TECHNICAL BULLETIN

TB-0192

ILJIN LBS semaphore cover defect

Retrofitting Semaphore Cover on 22kv Iljin Gas Switch

Figure 3 – Cover missing, showing low gas indication sticker (still operational)

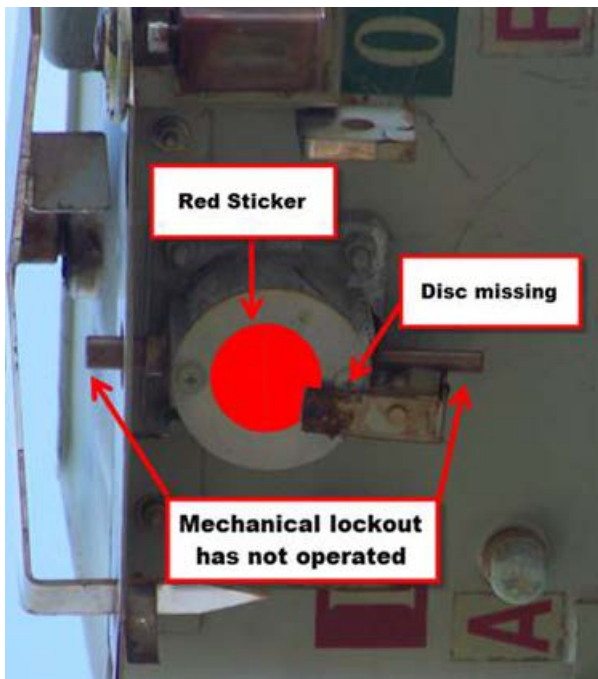
When this defect occurs, the switch is still safe to operate as the low gas mechanical lockout has not been activated. Another issue that has been observed is that the red low gas indicator sticker may have also fallen off the low gas mechanical lockout.

If any Ijin LBS are found to have a missing semaphore cover a defect shall be raised with a 6 month defect priority.

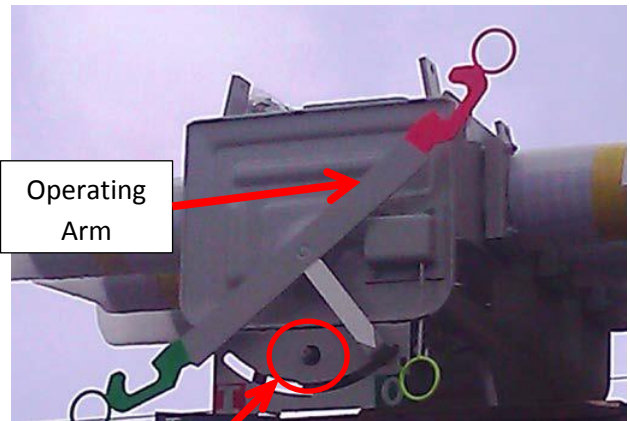
1. Assessing the position of the rod (circled in red in the adjacent figure). In this example, the rod has protruded by approximately 100mm and is preventing the movement of the operating arm. In this case, the switch **has locked out due to a low gas**.
2. Assessing the position of the bracket that the semaphore cover is normally attached to (circled in yellow in adjacent figure). In this example, the bracket is facing towards the switch indicator and is thus considered to be operational.

If the operating arm of the switch is impeded by the protruding rod (circled in red), the switch **has locked out due to a low gas** and cannot be operated.

If the bracket (circled in yellow) is facing the indicator as shown in this figure, the switch is considered operational.

If the switch is considered faulty, report this back to the control room and **do not** install the semaphore cover.

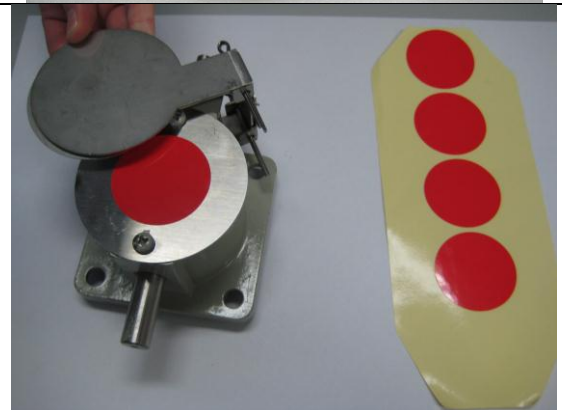
The replacement semaphore cover is shown in the picture on the right. Two split pins will be included in the assembly.

Mount the replacement semaphore cover on the back of the existing semaphore bracket / arm as shown in the adjacent figure.

Place the split pins through the existing holes in the replacement cover as indicated in the adjacent figure.
